Access Compliance Report

Public Rights-of-Way

(Pedestrian Signals)

Intersection ID: N/A	Main Street:	Cross Street: N/A	Location: N/A
ADA ID: D6417205C7B7	Signal Type: Two Push Buttons-Non APS	Overall Compliance: No	Severity Score: BTN 1:N/A BTN 2: N/A No BTN: N/A
Codes/Mitigation Info/Possible Solution		Field Measurements/Component Compliance

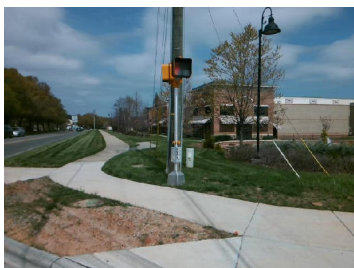
PROW/ADA: TMUTCD 4e.08, R404.7.3, R404.7.2

N/A	B 1 Clear Xing Direction?	Yes	N/A	B 2 Clear Xing Direction?	N/A
	B 1 Crossing Direction	To SW		B 2 Crossing Direction	To SE
Yes	B 1 DistanceTo XWalk (in)	27.0	Yes	B 2 DistanceTo XWalk (in)	48.0
No	B 1 DistanceTo Curb (in)	143.0	No	B 2 DistanceTo Curb (in)	143.0
Yes	B 1 Diameter (in)	2.0	Yes	B 2 Diameter (in)	2.0

Possible Solutions: Replace Signal Push Button With APS Button on New Post. Remove & Relocate Sign.
